**Re: Response to matters raised at Russell Vale Underground Expansion Project
Public Hearing**

We refer to the Public Hearing for the Russell Vale Underground Expansion Project (the Project) held by the Independent Planning Commission (IPC) on 19 and 20 October 2020. This letter provides a response on behalf of Wollongong Coal Limited (Wollongong Coal) to a number of matters raised in public submissions during the Public Hearing.

Figure 1 Plan showing location of swamps and proposed first workings in the Wongawilli Seam relative to previous secondary extraction in Bulli Seam (Grey), Balgownie Seam (Red) and Wongawilli Seam (Dark Green)⁹

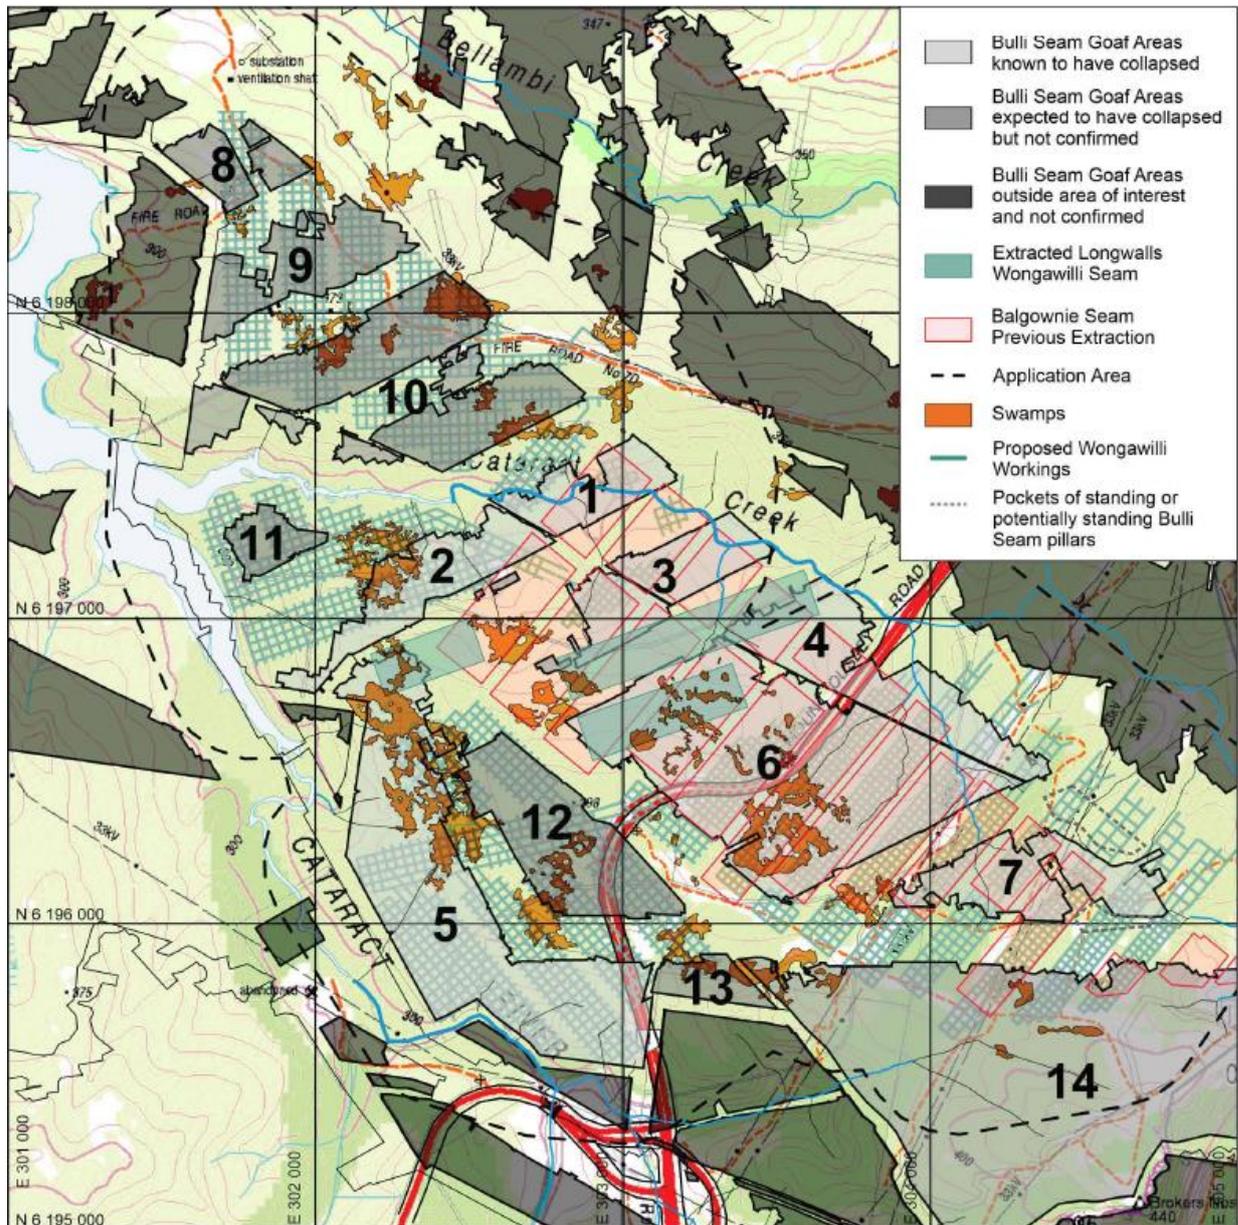
10. The existence and distribution of any marginally stable pillars in the Bulli Seam must be established.

A detailed review of the distribution and status of any potentially standing pillars in the Bulli Seam was undertaken as part of the peer reviewed Quantitative Assessment of Risk of Pillar Failure⁷ described in the above response. The location of Bulli Seam goaf areas yet to be confirmed as fully collapsed is provided as Figure 1 in this assessment and replicated as **Figure 1** below. The mine plan was developed based on analysis of historical mining.

As noted in the above response, confirmation that the seven Bulli goaf areas in question have in fact fully subsided will be obtained during roadway development within the Wongawilli Seam. This will involve monitoring of roadway conditions, ground movement and abutment loading in the Wongawilli Seam roadways below goaf edges to provide data on the condition of overlying strata. Monitoring will be supported by TARPS for roof support that will identify appropriate levels of roof support based on ground conditions. This monitoring process will be addressed as part of the Extraction Plan required by the draft conditions of consent proposed by NSW DPIE.

FIGURE 2

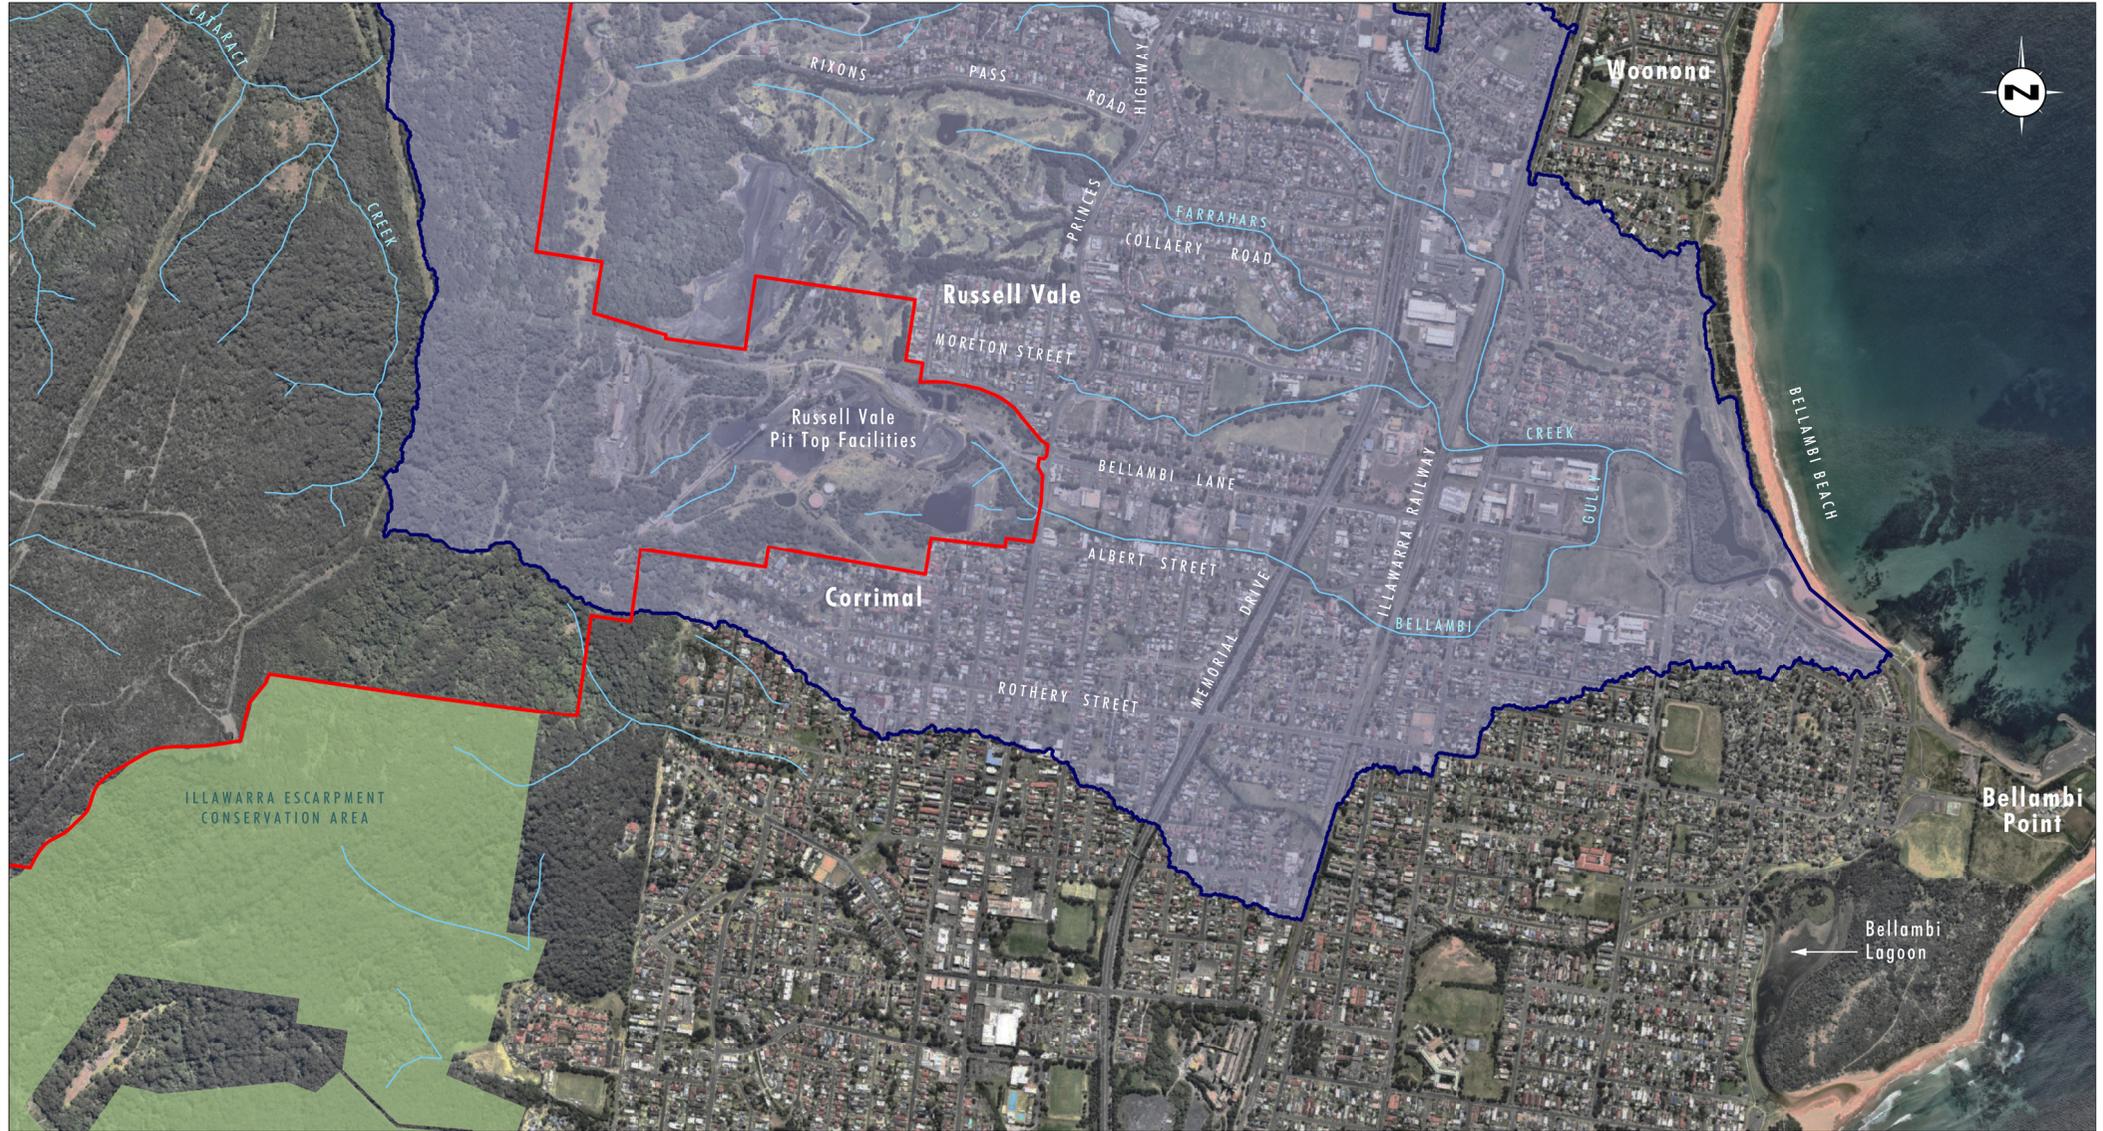
13. *The Project will impact water quality in Bellambi Lagoon and the current EPL does not protect the environmental values of the lagoon.*

The Russell Vale Colliery Pit Top is located entirely within the catchment of Bellambi Gully Creek (refer to **Figure 2**). Bellambi Gully Creek flows to the ocean at the southern end of Bellambi Beach, north of Bellambi Point.

Bellambi Lagoon is located south of Bellambi Point on Corrimal Beach and is not located within the catchment area of Bellambi Gully Creek. Bellambi Gully Creek does not flow into Bellambi Lagoon. The Project will therefore not impact water quality in Bellambi Lagoon.
